28F016XD

SPECIFICATION UPDATE

Release Date: November 1996

Order Number 297555-008

Operation Delay after Power-Up and Exit from Power-Down or Reset

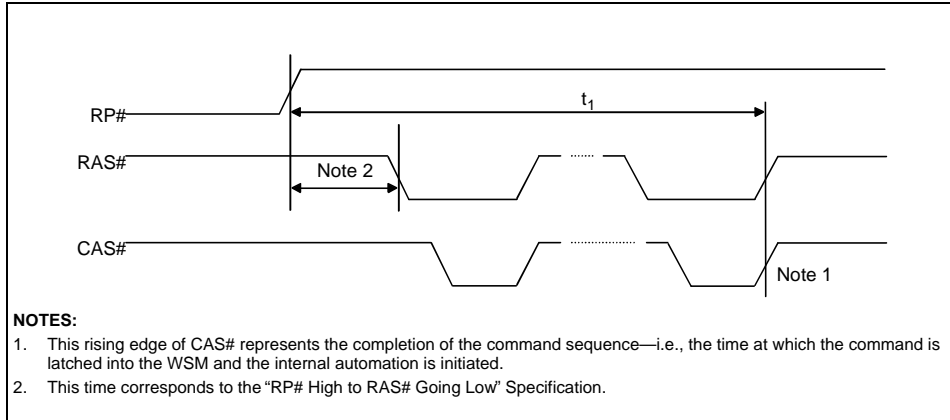
PROBLEM: With the program/erase voltage (V_{PP}) at 5V, the internal V_{PP} detector may not stabilize for up to 5 μ s (illustrated by t_1 in the figure, *Operation Delay after Power-Up and Exit from Power-Down or Reset*, which follows) after RP# transitions inactive (high). This causes an invalid V_{PP} Level bit indication when reading the Block Status Registers and termination of program, erase or lock block operations due to invalid device V_{PP} error detection. Affected operations include Word Write (40H/10H), Block Erase (20H) and Lock Block (77H).

IMPLICATION: 5V V_{PP} power-up/reset time delay to first program or erase operation is impacted.

WORKAROUND: Upon reset, power-up, or wake-up from software sleep or hardware deep power-down, allow 5 μ s (t_1) before initiating a Write/Erase command (as listed earlier) or reading the V_{PP} Level bit of the Block Status Registers (BSR.1). The figure below illustrates this timing requirement (t_1) in more detail.

Operations are initiated by the device on the rising (trailing) edge of the last CAS# pulse in the command sequence. Two-cycle command operations such as Word Write or Erase are initiated on the rising edge of the CAS# pulse corresponding to the Address/Data or Confirm command.

Example System Software Flowchart That Will Not Encounter “Completion with Command Error” Condition

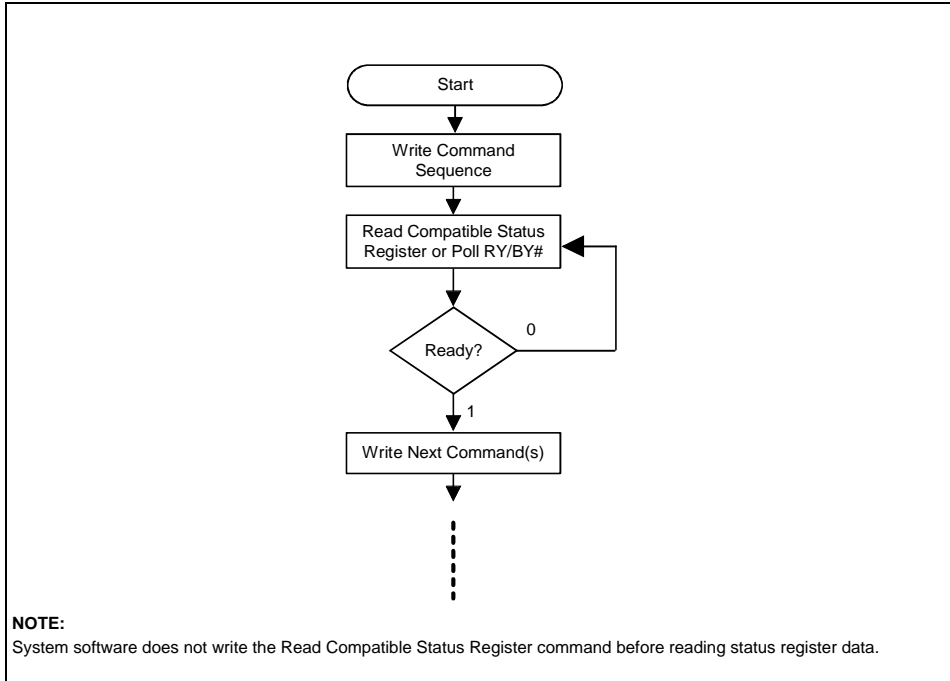
PROBLEM: Systems in which software, after initiating device automation, writes another command(s) to the device before automation completes may initiate unintended device operations.

These unintended operations will produce an invalid command error indication. A command error is indicated by a “1” in the following Status Register bits:

Systems that poll the RY/BY# pin or WSMS bit (CSR.7) for “Ready” indication before writing another command to the device will not encounter this erratum. This is illustrated in the *Example System Software Flowchart, etc. figure* (which follows), and flowcharts 11-1 and 11-2 (without erase suspend) of the *16-Mbit Flash Memory Product Family User’s Manual*.

Erase Suspend to Read Array with Compatible Status Register

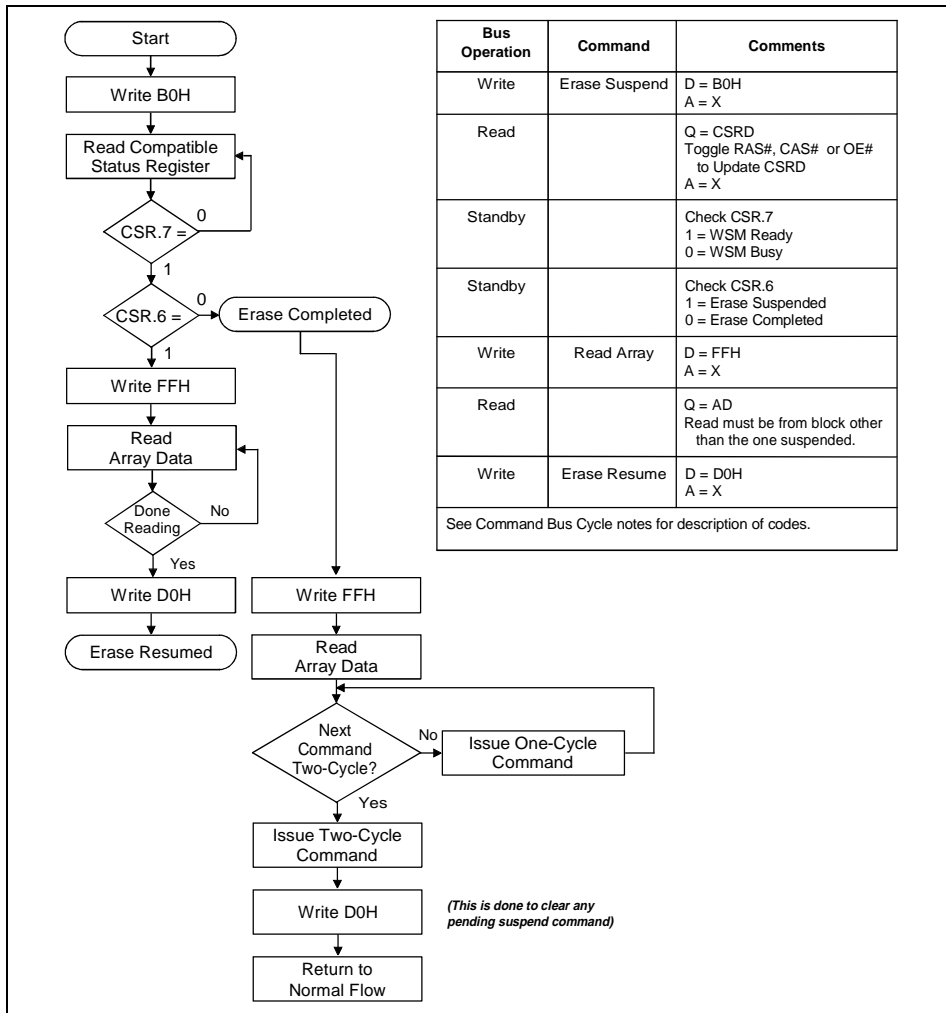
PROBLEM: If an Erase Suspend command is issued late in the Erase algorithm, it will not be recognized by 28F016XD components listed in the Affected Devices section, and erase will complete. This Erase Suspend command will **not** be discarded.

- A. If another Erase command is issued at some time later, the device then assumes that the pending Suspend request is still valid and will automatically Suspend the current Erase.
- B. If any queueable command is in the command queue waiting for execution while another queueable command is in progress, the Write State Machine will suspend its operation after completing the current command. (Refer to *the 16-Mbit Flash Product Family User's Manual*, Section 11-1 for the queueable command list.)

WORKAROUND: A software workaround to this erratum inserts a redundant Resume command (D0H) immediately following any Two-Cycle Command (Word Write, Block Erase, Lock Block, or Upload Status Bits) in the Erase Suspend flowcharts. Modified Erase Suspend to Read Array flowcharts (Figures 11-3 and 11-12 of the *16-Mbit Flash Memory Product Family User's Manual*) detailing this workaround are shown in the *Erase Suspend to Read Array with Compatible Status Register* and *Erase Suspend to Read Array with Extended Status Register* figures, which follow. This erratum results in the *Erase Suspend with Compatible Status Register* flowchart being incompatible with the 28F008SA *Erase Suspend* flowchart.
